Staff Report

Re: **PLNPCM2018-01008 and PLNPCM2019-00255** Conditional Use and Conditional Building and Site Design Review for the Red Rock Brewhouse – Brewery and Tasting Room

PROPERTY ADDRESS: 426 West 400 North

RED ROCK BREWING CO. BREWHOUSE III

C3 SOUTH ELEVATION
AE2-01 SCALE: 1/8"=1'-0"

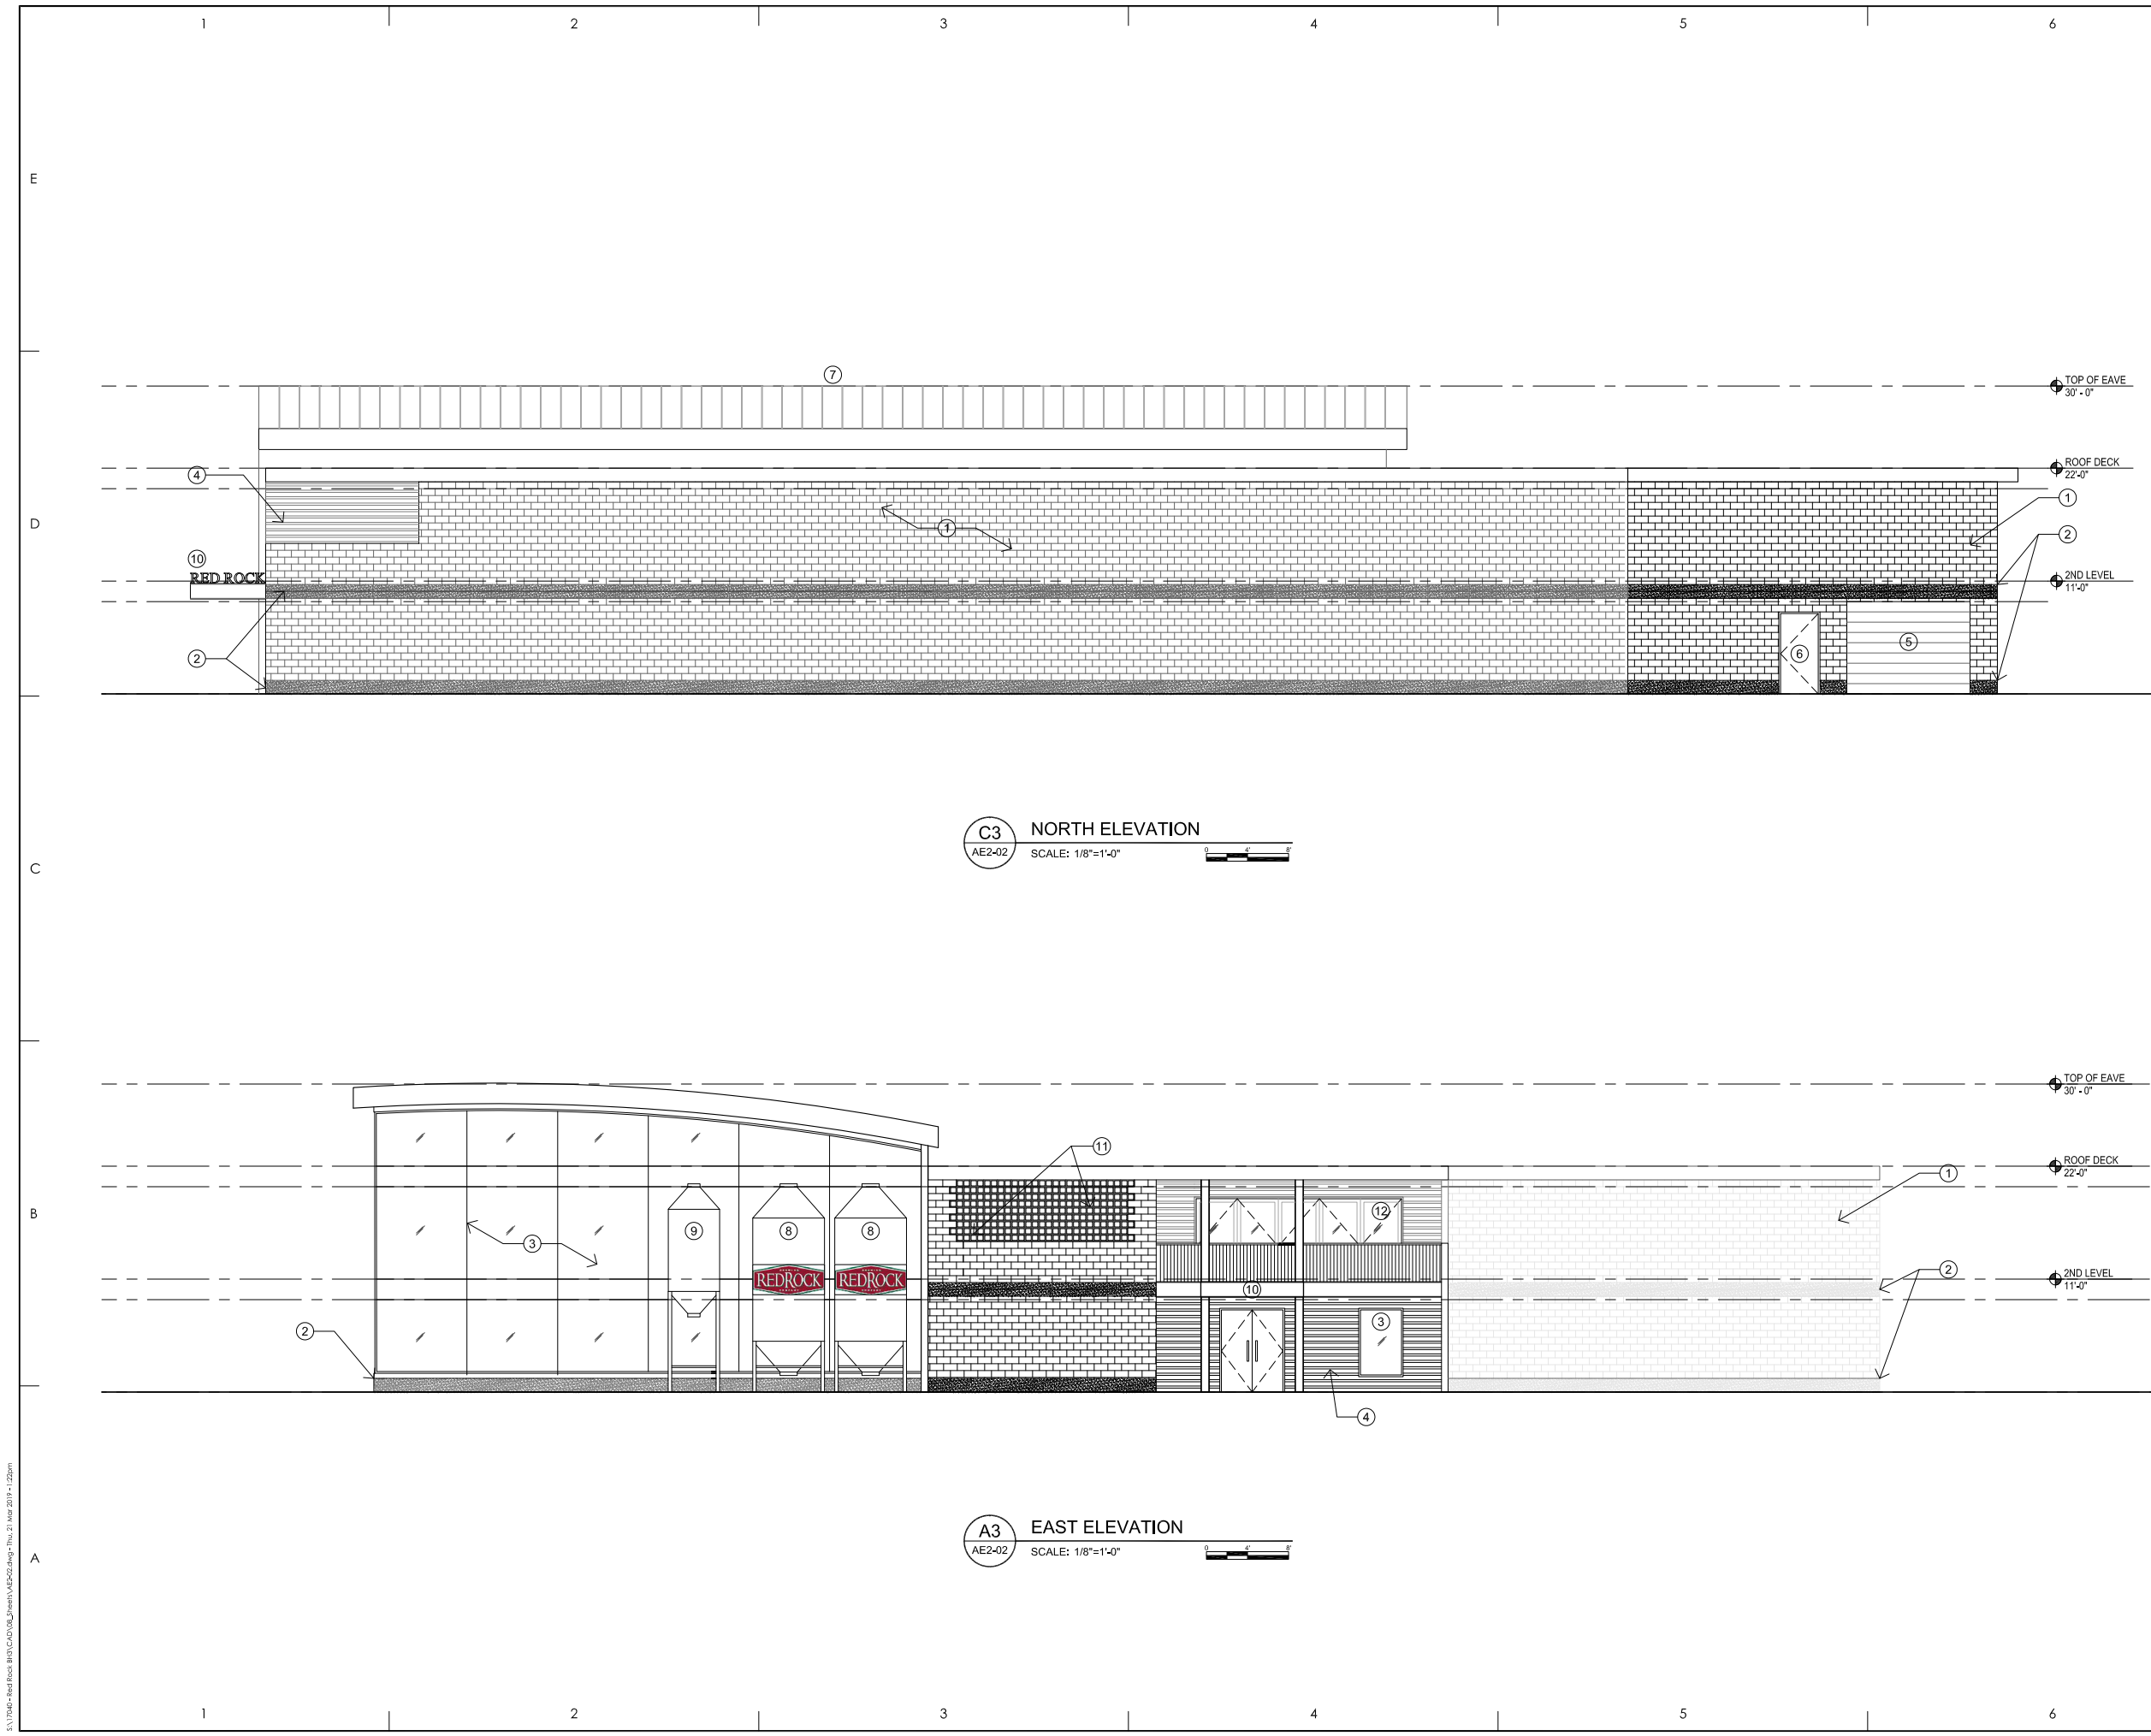
1. *Artwork, a mural or other element of visual interest along the south elevation is required in order to break up the blank wall space and provide the appearance of activity.*
2. *One additional doorway must be located along the south elevation in order to break up the blank wall space.*
3. *Final approval of landscaping, signage, lighting and the visual addition on the south façade is delegated to Planning Staff to ensure compliance with applicable standards.*
4. *Any modifications to the approved plans after the issuance of a building permit must be specifically requested by the applicant and approved by the Planning Division prior to execution.*
5. *Applicant shall comply with all other department/division requirements.*

standard is to provide active building frontages that add interest, life, and vitality to the public realm. On the south and east facing street level façades, the proposed design incorporates walls that exceed that length. The south elevation includes a section of blank wall that measures approximately 55-feet 4-inches in length and the east elevation includes a blank wall section that is approximately 21-feet in length. The applicant has stated that this is a response to the internal functions and programming of the building. The addition of extra glass on the south elevation is intended to partly offset this. As outlined in consideration 2 above, they are proposing to incorporate approximately 1411 square feet of glass on the south elevation which is well in excess of the required 508 square feet. The location of this however is part of the CBSDR modifications requested. The applicant's narrative also describes the material changes in terms of the brewery and brewery support functions and that additional windows may be added to the second level as offices once the building programming has been finalized. The blank wall and glass requirements pertain to the ground floor level so the addition of glass to the second floor level is not germane to meeting the regulations and cannot be guaranteed by Planning Staff nor is it something that would meet the Design Standards.

Planning Staff acknowledges the programming needs of the building as a consideration in regard to the requested modification to allow for larger blank wall spaces on the south elevation but has concerns about how this elevation will impact the pedestrian experience and street interaction due to the lack of detailing on the south facade. Planning Staff is recommending that the Planning Commission approve this modification to allow for a longer blank wall but require that the applicant integrate some kind of artwork, mural or other element of visual interest along that elevation in order to break up the blank wall space. Staff is including this as a condition of approval.

South Elevation Required per 21A.37.060

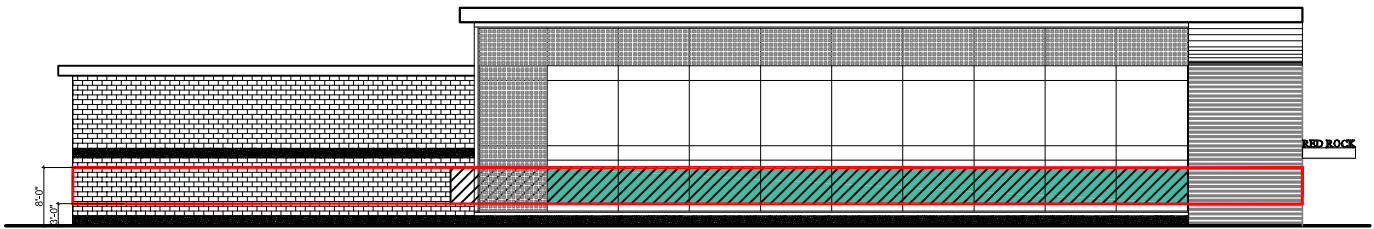
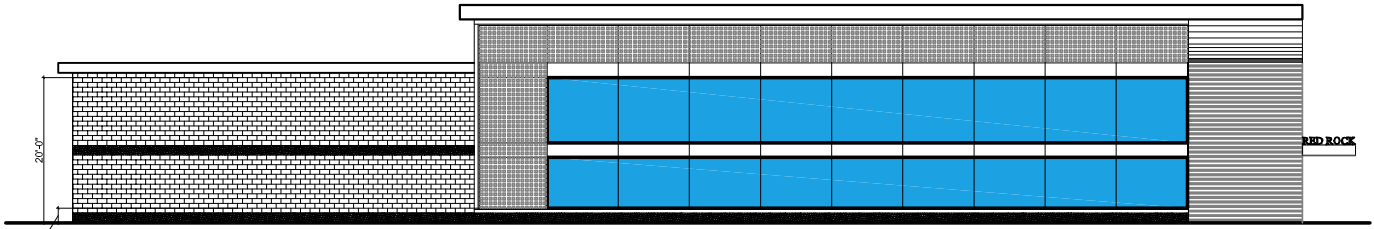
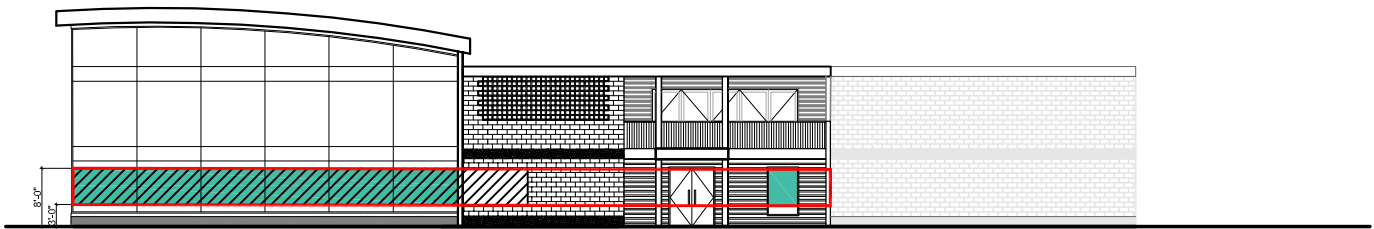
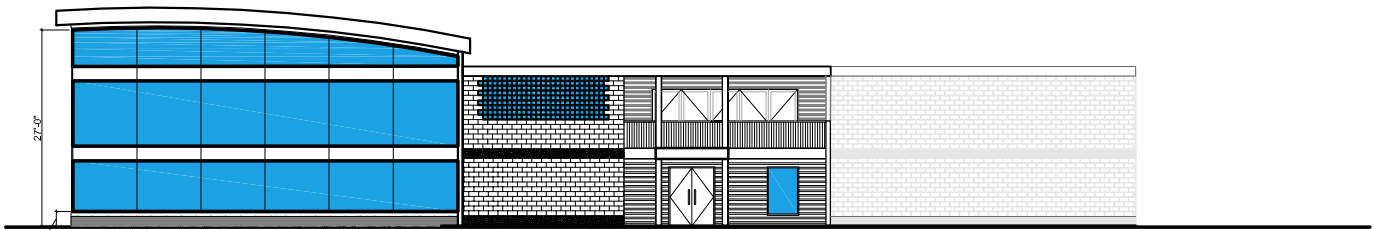
The ground floor glass requirements per Chapter 21A.37 – Design Standards specify that the street-facing facades must incorporate 60% glass in the area from three (3) to five (5) feet above grade. On the south-facing elevation toward 400 North, this would equate to approximately 508 square feet of glass being required within that zone. The applicant’s design concentrates the glass on the east side of the south façade, in between two (2) and twenty (20) feet above grade. As a result, they are proposing to provide approximately 1411 square feet of total glass area on that elevation, but only 441 square feet within the required 2 to 8 foot area above ground level.

On the east-facing elevation toward 400 W, the required glass between 3 and 8 feet is approximately 313 square feet. The applicant has proposed to incorporate a total of 1100 square feet of glass on that elevation, but only 285 square feet within the required area. The provided glass would be located between 2 and 27 feet above grade and is concentrated toward the south side and the corner of 400 N and 400 W. The requirements specify between 3 and 8 feet but the design put forth by the applicant extends lower (to 2 feet) and much higher (27 feet) above grade.

- C. GLASS: We have designed a 3 story corner glass element that does not meet the 60% glass in a 3'-0" to 8'-0" swath. Please see the diagram on page 4 with our proposed alternate glass calculations. Additional glass may also be added to these facades once the buildings program has been finalized.

Planning Staff is recommending that the Planning Commission approve this modification to the glass requirements as the development is exceeding the overall area of glass required and using it to create a pedestrian focal point toward the corner of the building.
